Building Permit Application

Permit No. B17002377

MEMORANDUM

**PERMIT SITE PLAN
 LOT 133
 5028 LINDERA COURT
 WALNUT CREEK**

1 PARTIAL SECOND FLOOR PLAN
SCALE: 1/4" = 1'-0"

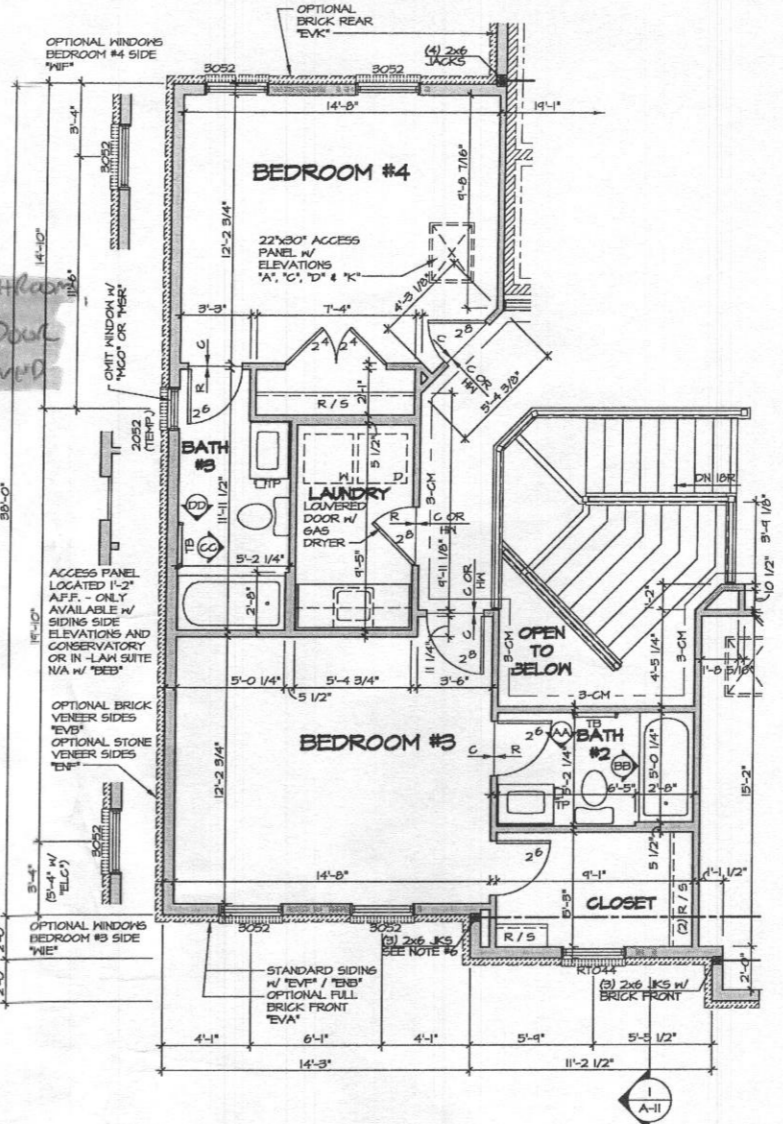
CLOSET, BATHROOM AND ENTRY DOOR WILL BE REMOVED
